Mack Chassis - Transmission Harness Wrap Failure Causing Open Or Short Circuits, Possible Datalink Fault Codes

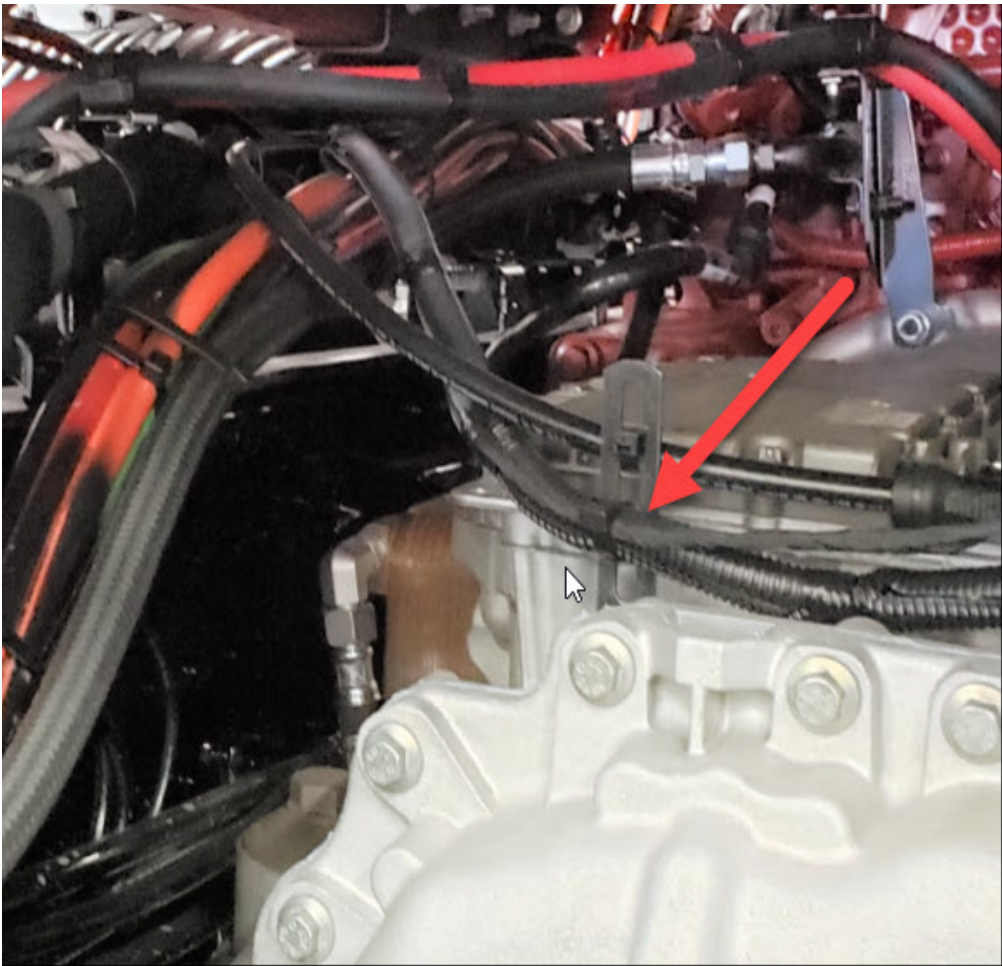
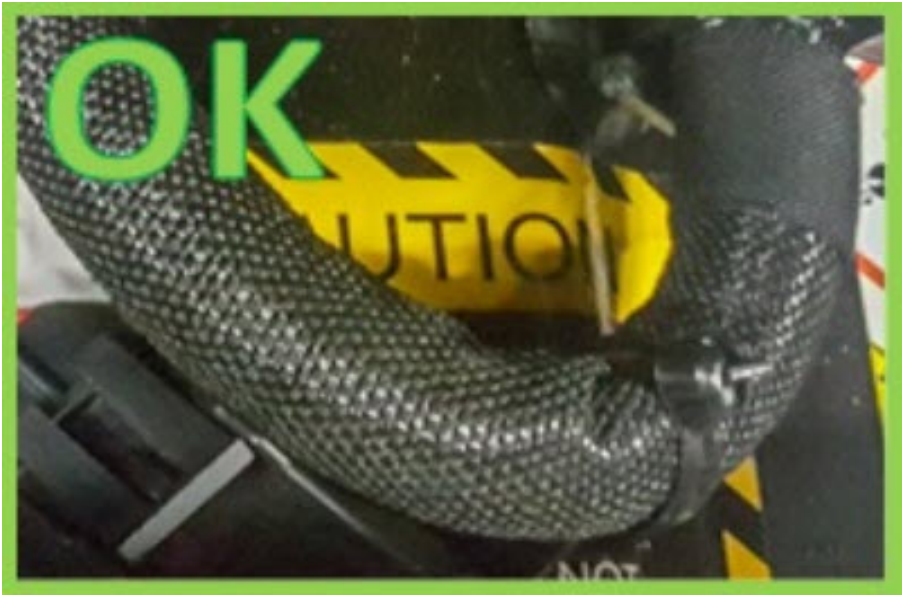
Vehicles built between 26 September 2016 and 25 September 2020 with AMT-F (mDrive) transmissions may have been assembled with transmission harnesses that were wrapped with split convoluted tubing. Split convoluted tubing in this application can damage wiring insulation which can lead to open or short circuits and datalink fault codes.

Updated transmission harnesses are available that use woven cloth tape and heavy duty wrap to protect the wiring from damage. See illustrations below.

Updated Transmission Harness Part Number	
Without crawler gears	23919978
With crawler gears	23919976
